CERTIFICATE OF APPROPRIATENESS

Property: 1524 Ashland Street, Lot 25.26, Block 145, Houston Heights Subdivision. Situated on a 8,799.12 square foot (132 'x 66.66') lot, the 1,218 square foot main property stands on the interior lot.

Proposal: Resubmittal - See attached Report.

Details: Alteration – Addition, Foundation, Siding

WEST ELEVATION – FRONT FACING STREET

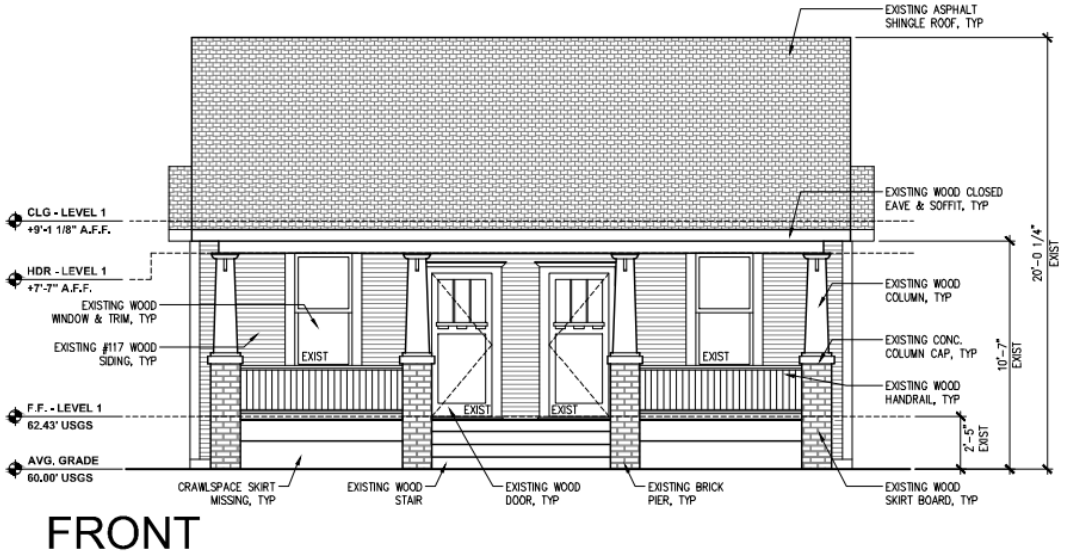
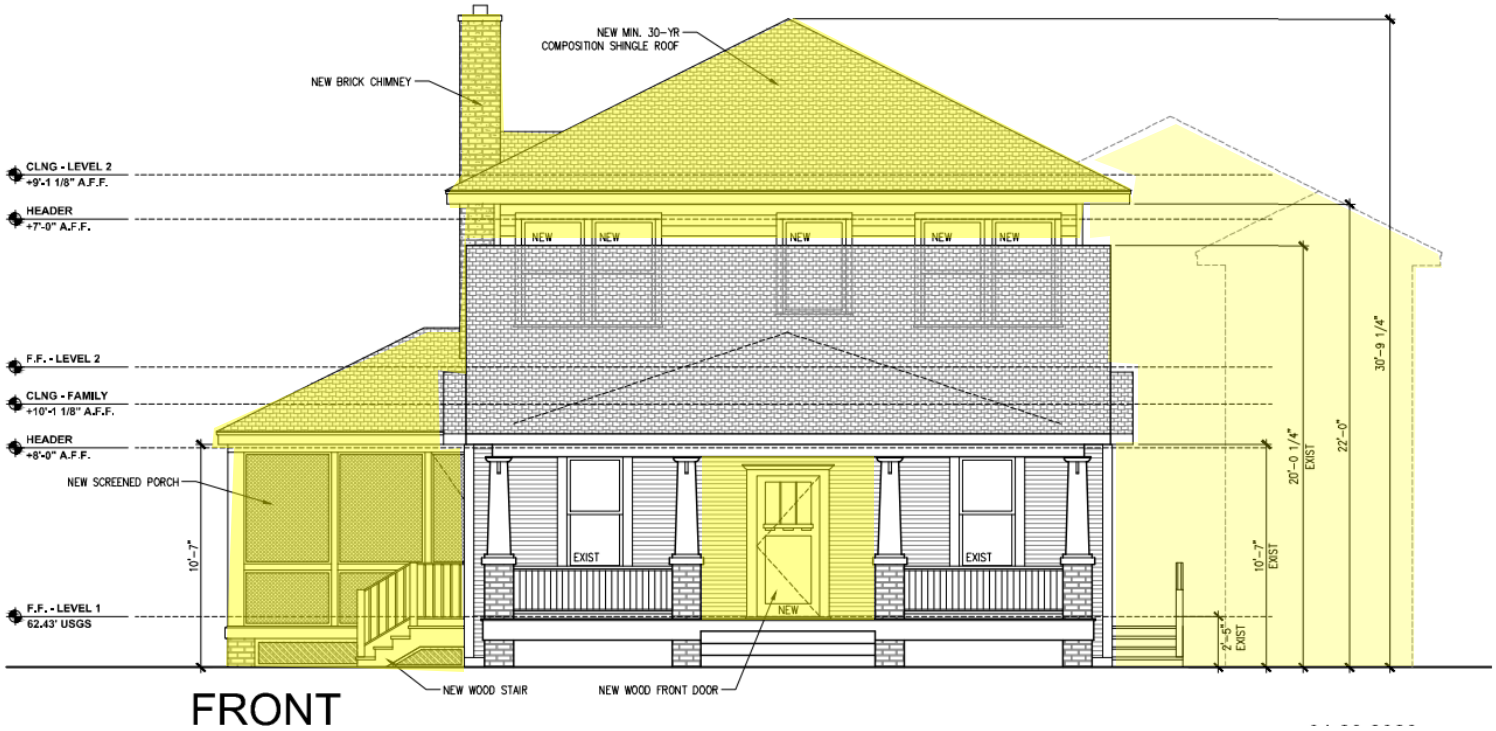
S	D	NA		S - satisfies D - does not satisfy NA - not applicable
☒	☐	☐	(1)	The proposed activity must retain and preserve the historical character of the property; Condition: Per written agreement, agent will alter plans to retain historic front elevation entrances and both side elevation windows. Agent will present revised final plans before permitting.
☒	☐	☐	(2)	The proposed activity must contribute to the continued availability of the property for a contemporary use;
☒	☐	☐	(3)	The proposed activity must recognize the building, structure, object or site as a product of its own time and avoid alterations that seek to create an earlier or later appearance;
☒	☐	☐	(4)	The proposed activity must preserve the distinguishing qualities or character of the building, structure, object or site and its environment; Condition: Per written agreement, agent will alter plans to retain historic front elevation entrances and both side elevation windows. Agent will present revised final plans before permitting.

☒	☐	☐	(5)	The proposed activity must maintain or replicate distinctive stylistic exterior features or examples of skilled craftsmanship that characterize the building, structure, object or site; Condition: Per written agreement, agent will alter plans to retain historic front elevation entrances and both side elevation windows. Agent will present revised final plans before permitting.
☒	☐	☐	(6)	New materials to be used for any exterior feature excluding what is visible from public alleys must be visually compatible with, but not necessarily the same as, the materials being replaced in form, design, texture, dimension and scale;
☒	☐	☐	(7)	The proposed replacement of exterior features, if any, should be based on an accurate duplication of features, substantiated by available historical, physical or pictorial evidence, where that evidence is available, rather than on conjectural designs or the availability of different architectural elements from other structures;

Windows/Doors: See window/door schedule, PROPOSED reconfigures duplex front entrance to single door and removes "early" windows at side elevations on original building (4 total).

- Existing side windows: we would prefer to present the changes as shown to the commission, and defer should they not agree. Or perhaps, seek a conditional approval with the condition that the windows remain. If the opportunity arises such that these windows can be restored and repurposed on the front of the home, flanking a single-entry door, we would be supportive of this.

PHOTOGRAPHS

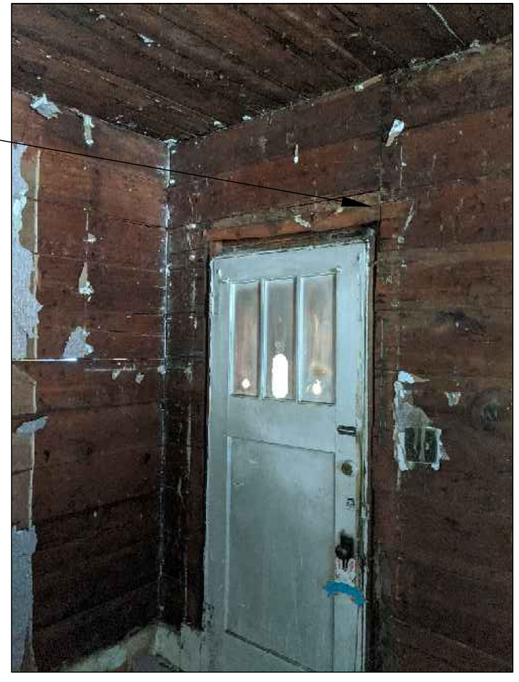
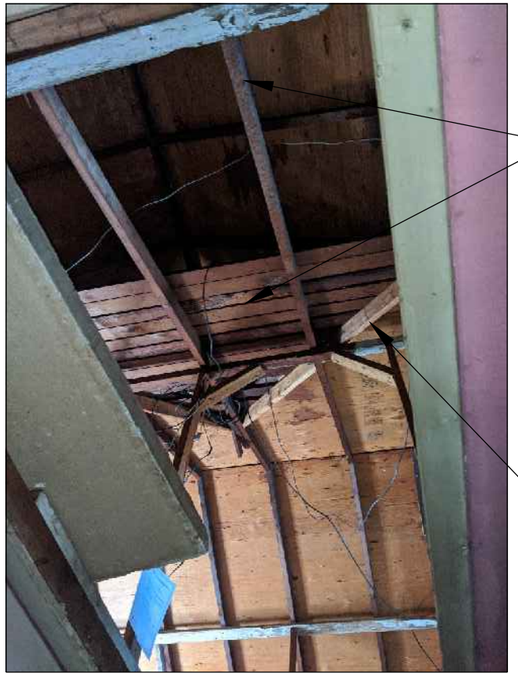
IN-LINE DAMAGED SHIPLAP SHOWS PLACEMENT OF DOOR TO BE UNORGINAL
